SERVICE BULLETIN

TR-2400

#815

SUBJECT: TR-2400 PULSE NOISE

TX RF NOISE:

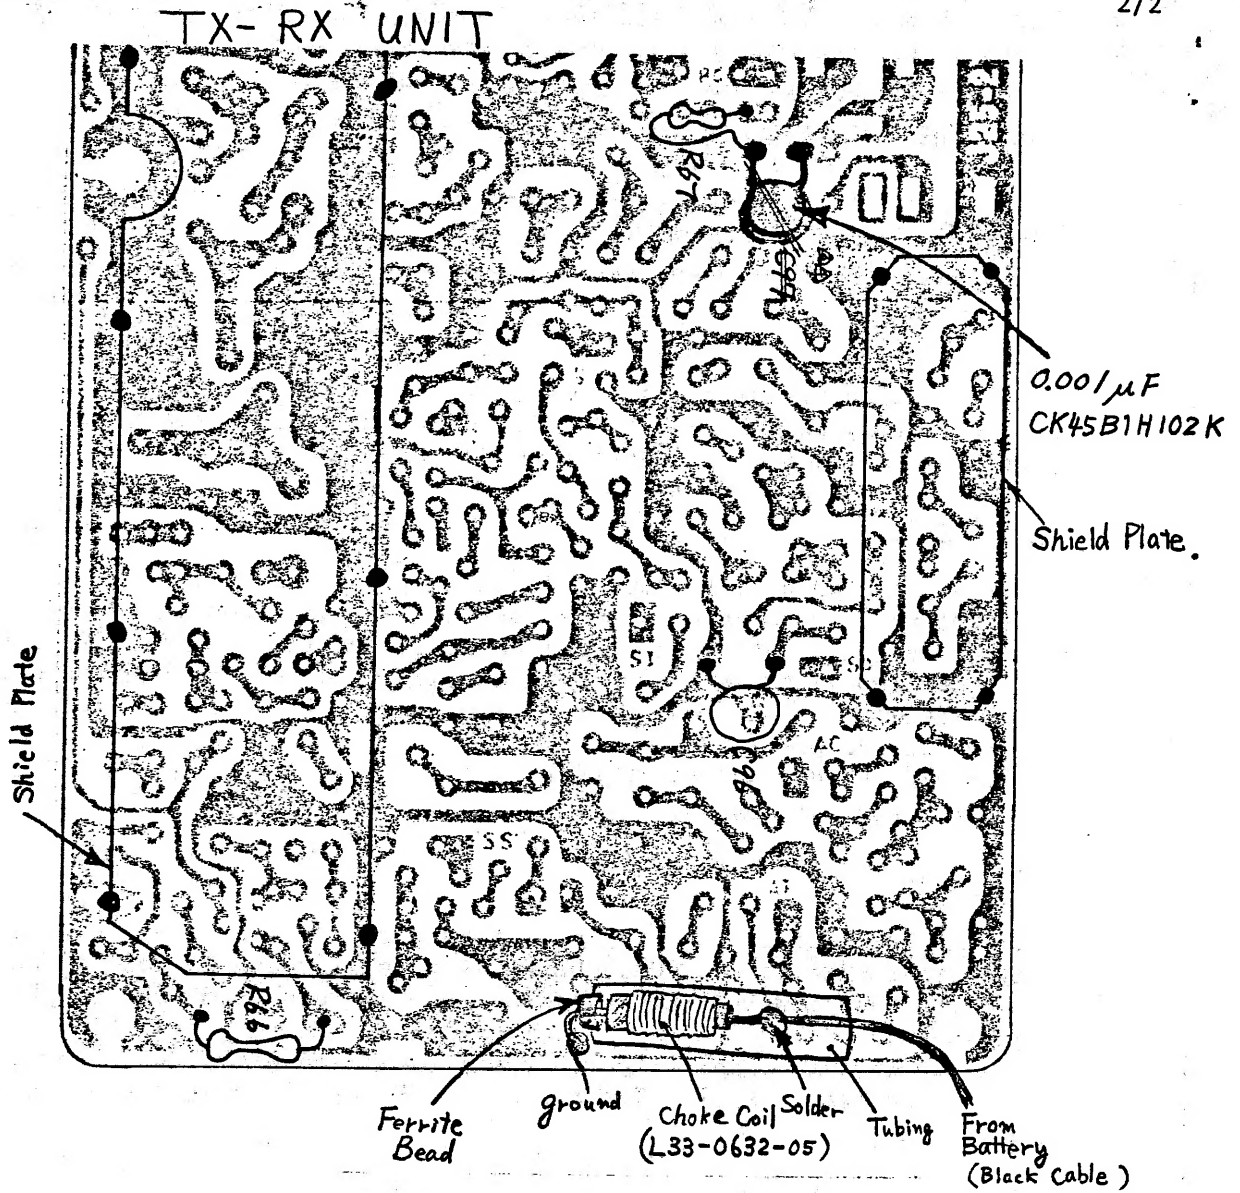
1. On the RX TX unit, locate the battery ground (BLACK) lead soldered to the right edge of the PCB. Desolder this line and install a choke with ferrite bead L33-0632-05 Resolder along the bottom edge of the board, as shown.
2. Also on the RX TX unit, locate the YELLOW lead attached to the foil side of the charge jack J1. Install a .001uF capacitor across J1 to ground as shown.

1. On the display unit X54-1480-10 locate the YELLOW lead marked B+. Desolder this lead and install a 1uH choke L40-1021-03 in series. Lead dress MUST be as shown for physical clearance.
2. Also on the Display unit, adjacent to the B+ lead, desolder the GREEN E (earth) lead and the BLACK E lead, and wire as shown to another 1uH choke, L40-1021-03. Again, observe physical parts placement for clearance.
3. For reassembly, reverse steps 5 through 1. If components were installed as specified, there will be no clearance problems.
